REPLACEMENT OF FUEL PUMP FOR ROTAX® ENGINE TYPE 912 (SERIES) SB-912-053UL

FOR ROTAX® ENGINE TYPE 912 (SERIES) SB-912-053

Replacement of fuel pumps for ROTAX® Engine Type 912 (Series)

ATA System: 73-00-00 Fuel system

(see Fig.1)

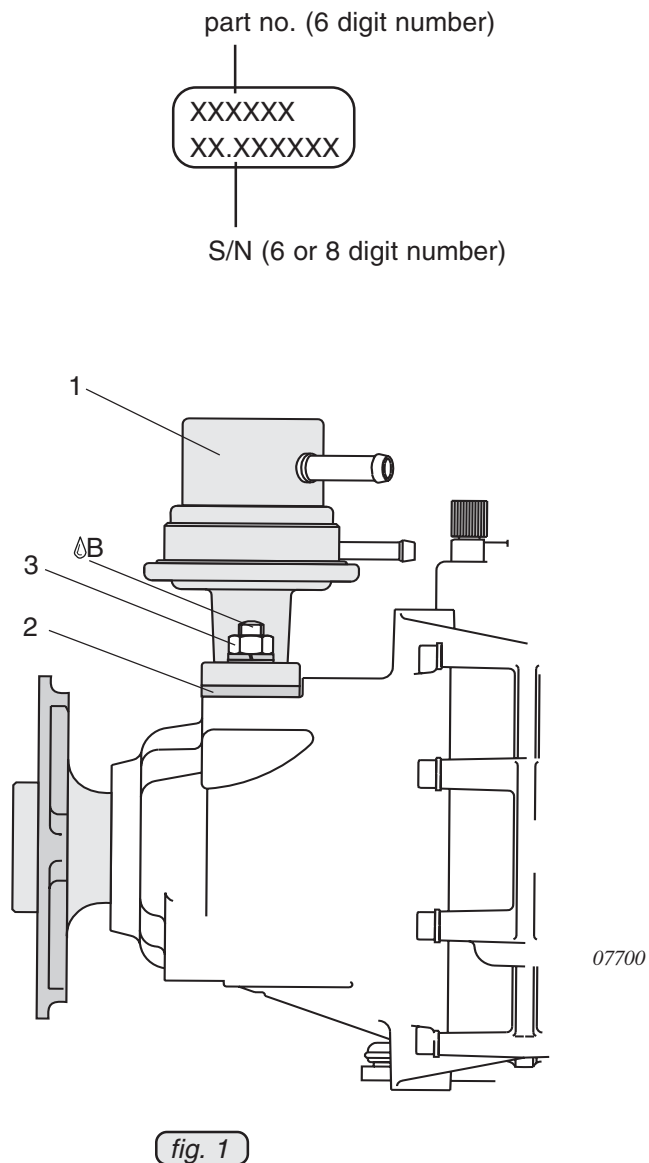
1. Remove fuel pump (1).
2. Gasket (2) replaced by new part.

■ **CAUTION:** Install new gasket supplied with new fuel pump. Do not reuse old gasket.

3. Install fuel pump.

4. Tighten uniformly hex. nuts (3) with LOCTITE 243. Tightening torque 15 Nm (133 in.lb).

Fig. 1

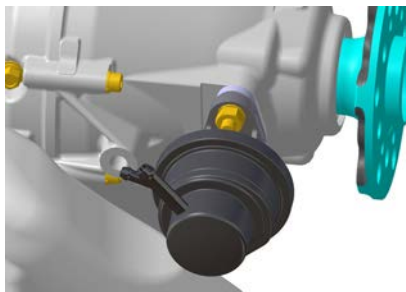
3.1.1) Removal of fuel pump part no. 892542 (without crimped hose assembly), see Fig. 1

Step	Procedure
1	Remove fuel hoses as per aircraft manufacturers instructions. NOTE: Make note of orientation of the hoses (inlet/outlet).
2	Loosen hex. nuts (13 mm/0.51 in) and remove fuel pump with lock washer A8 and insulating flange (gasket).

Fig. 2

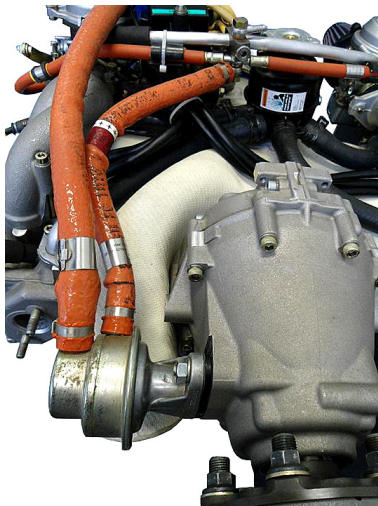
3.1.2) Removal of fuel pump part no. 892546 (with fire sleeve), see Fig. 2

Figure shows fuel pump part no. 892546 with crimped fuel hose assy. and fire sleeve.
Fuel pump

Fig. 3

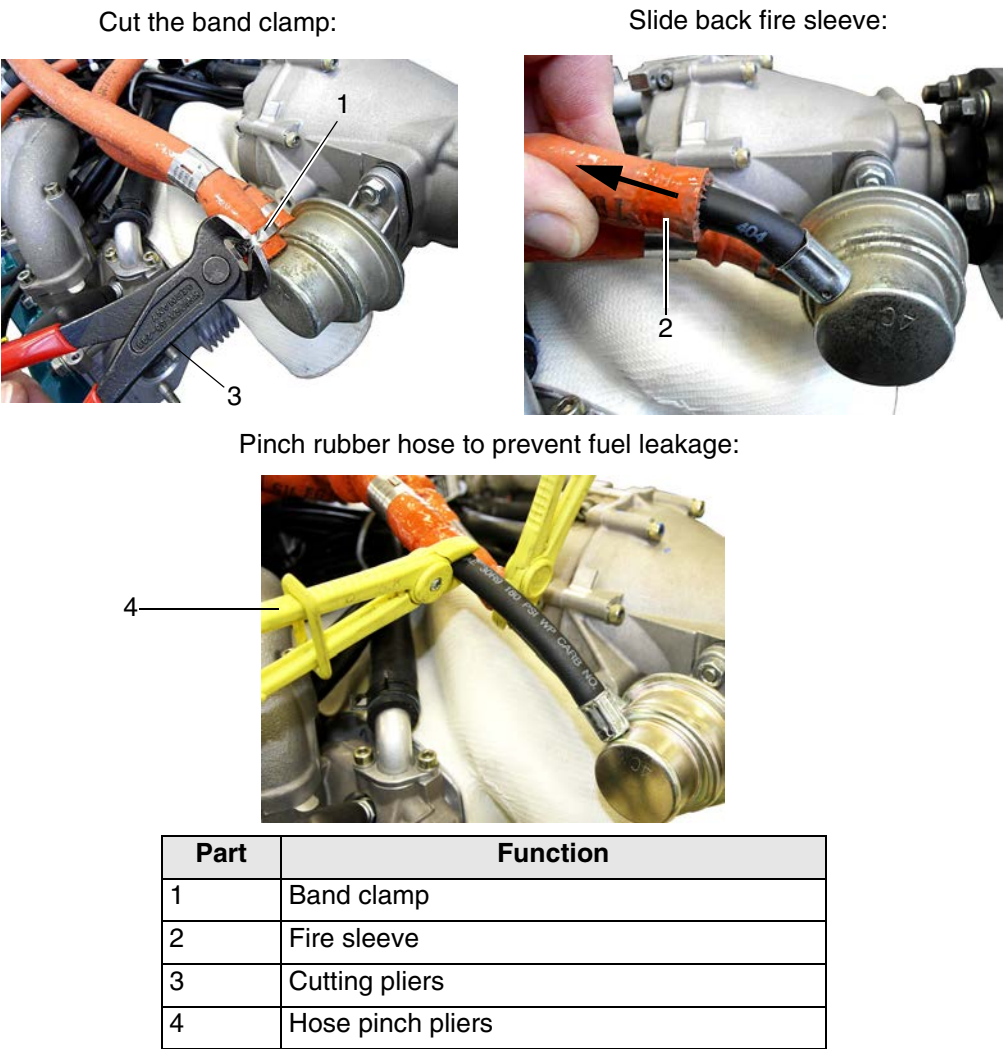
The following work steps are necessary (see Fig. 3):

Step	Procedure
1	Cut off the 1-ear clamp (1) of fire sleeve (2) with cutting pliers (3).
2	Slide back the fire sleeve (2) to make fuel hose accessible for cutting.
3	Pinch off the fuel hose with hose clamp pliers (4).

Fig. 4

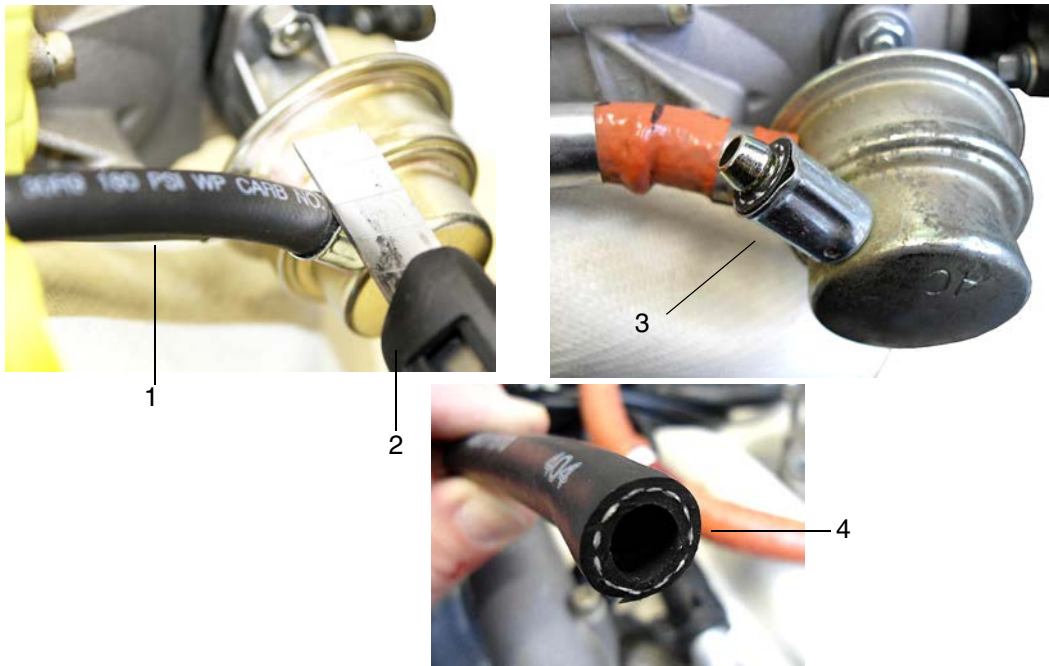
NOTE: Cut off the fuel hose with a very sharp knife, so that no cutting residues are produced. See Fig. 4.

Step	Procedure
4	The cut should be made adjacent to the crimped ferrel, to avoid losing any needed length. The fuel hose is reduced by approx. 20 mm (0.79 in.). NOTE: Make note of orientation of the hoses (inlet/outlet) A clean cut surface is very important!
5	Repeat procedure at the second fuel hose assy.

Fig. 6

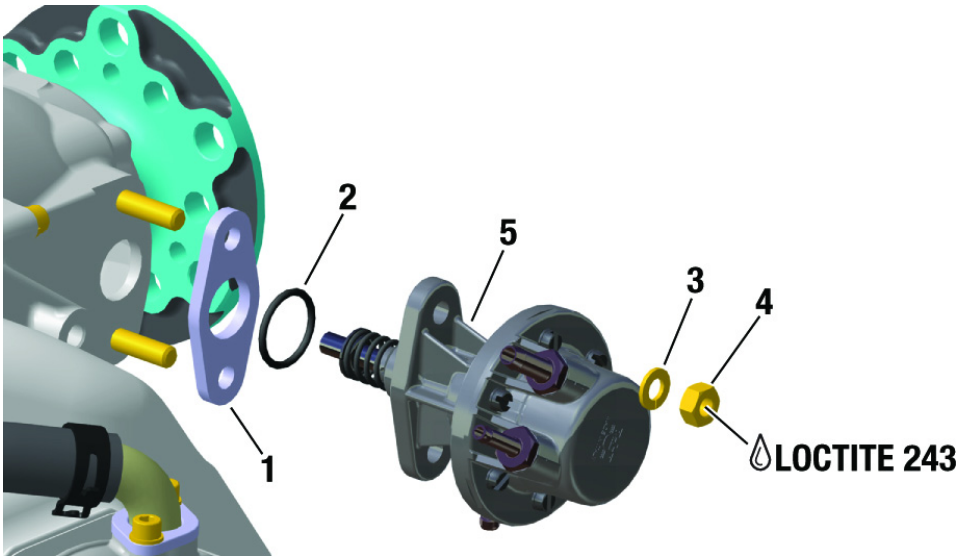
3.2) Assembling of fuel pump assy. part no. 893110

In addition to the insulating flange (gasket) also replace the O-ring at reassembly or assembly of the fuel pump.
Both parts are included in the set of fuel pump assy.

Ensure the O-ring is located in the recess in the fuel pump, before installing the fuel pump!

Step	Procedure
1	Install fuel pump (5) with new insulating flange (gasket) (1) and O-ring (2).
2	Secure new hex. nuts M8 (4) and lock washer A8 (3) with LOCTITE 243 and tighten them evenly. Tightening torque 15 Nm (133 in.lb).

Fig. 7

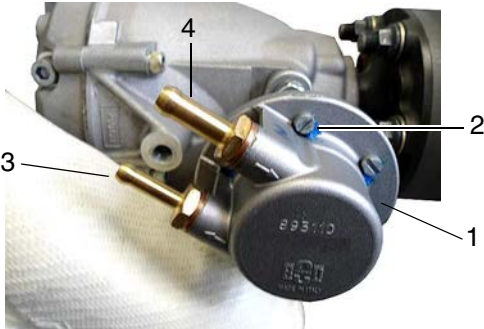
See [Fig. 7](#).
The fuel pump cover (1) must not be opened for inspection. Check the security markings (witness paint) (2).
Check the connecting nipples (3)+(4) for tightness. If necessary secure them with LOCTITE 243.
Tightening torque 10 Nm (88.5 in.lb).
- Graphic

Step	Procedure
1	Connect the hose from the fuel tank to the connecting nipple identified as 4 in Fig. 7 .
2	The hose that goes to the carburetors should be connected to the connecting nipple identified as 3 in Fig. 7 . NOTE: After installation of the hoses ensure the fuel tap is turned back ON.

Fig. 8

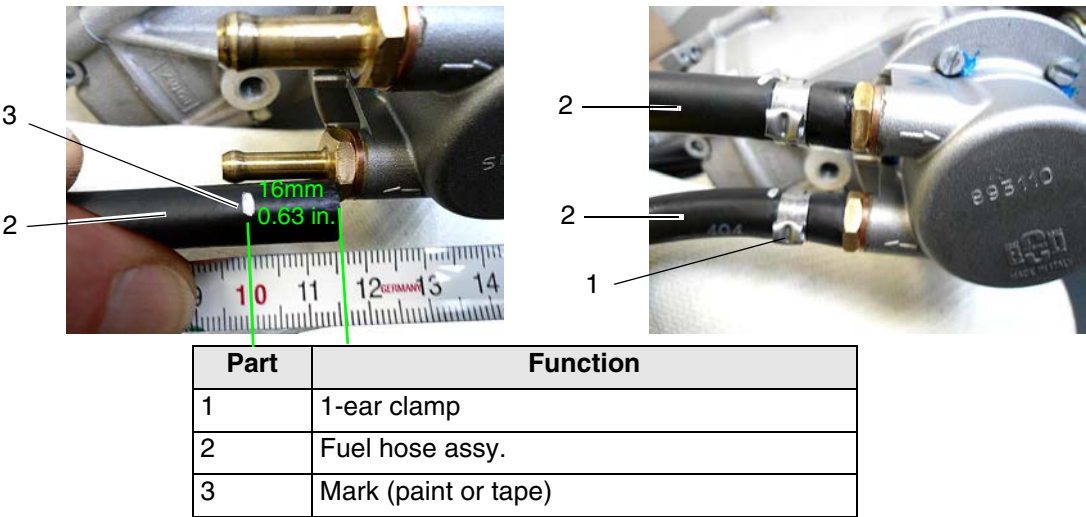
3.4.2) Assembling of the fuel pump part no. 893110 when replacing fuel pump part no. 892546

Step	Procedure
1	Remove hose clamp pliers from fuel hose assy.

Step	Procedure
2	Before the fuel hose (2) is fitted with a 1-ear clamp (1), the two fuel hoses have to be marked (3) 16 mm (0.63 in.) from the end of the hose (2).
3	Slide all 4 1-ear clamps (1) on the fuel and fire sleeves. NOTE: Clamps part no. 853313/851663 on fire sleeve and clamps part no. 851463/851453 on fuel hose.
4	Slide the fuel hoses (2) onto nipple completely up to the end stop.
5	Crimp 1-ear clamp (1)- outlet side part no. 851463 with suitable crimp pliers . NOTE: The edge of the 1-ear clamp (1) must align with mark (3) from fuel hose (2) , because otherwise there is too little space for the 1-ear clamp (1) of the fire sleeve.
6	Repeat steps on inlet-side with 1-ear clamp (1) part no. 851453 for fuel hose assy. (2).

Fig. 9

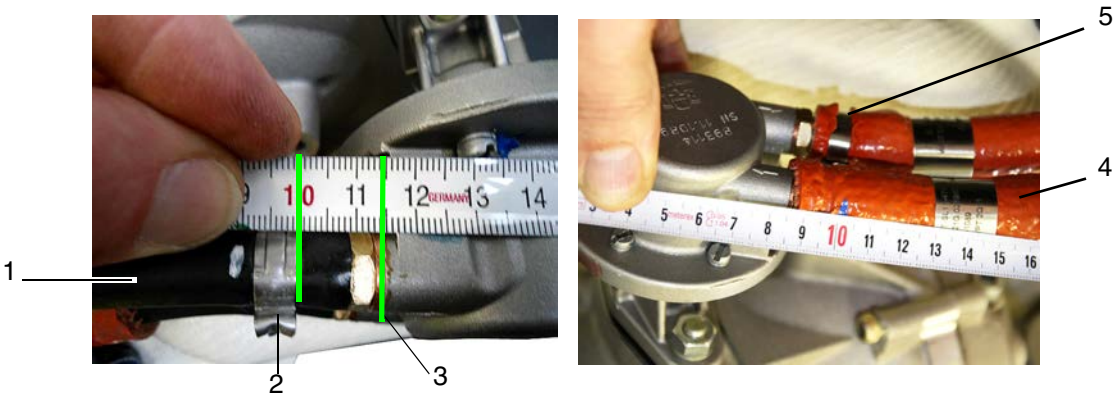
The distance from the 1-ear clamp (2) to the nipple flange (3) has to be measured, so that the outer 1-ear clamp (5) can be mounted on the fire sleeve (4) in the correct position.

Step	Procedure
1	Measure the distance at fuel hose assy. (1) from 1-ear clamp (2) to nipple flange sealing surface (3) and mark the fire sleeve (4) correspondingly. NOTE: The clamp securing the fire sleeve should be as close as possible but without impeding on the fuel hose clamp

Fig. 10

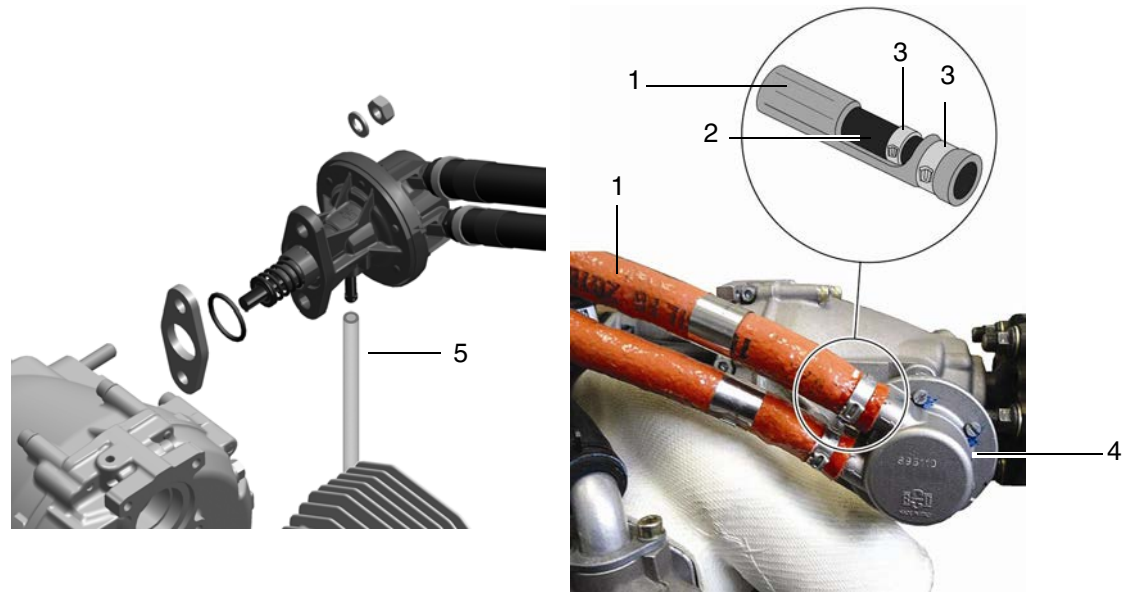
Step	Procedure
2	Push fire sleeve (fuel inlet) to stop and mount 1-ear clamp (17.8-21.0 mm/0.70-0.83 in.) with suitable crimp pliers.
3	Repeat steps for fire sleeve (fuel outlet) (22.4-25.6 mm/0.88-1.01 in.).

A drain line must be installed, that in the event of a internal leak any fluid is drained to a suitable location/position. See therefore Installation Manual of the relevant engine type and SI-912-020.
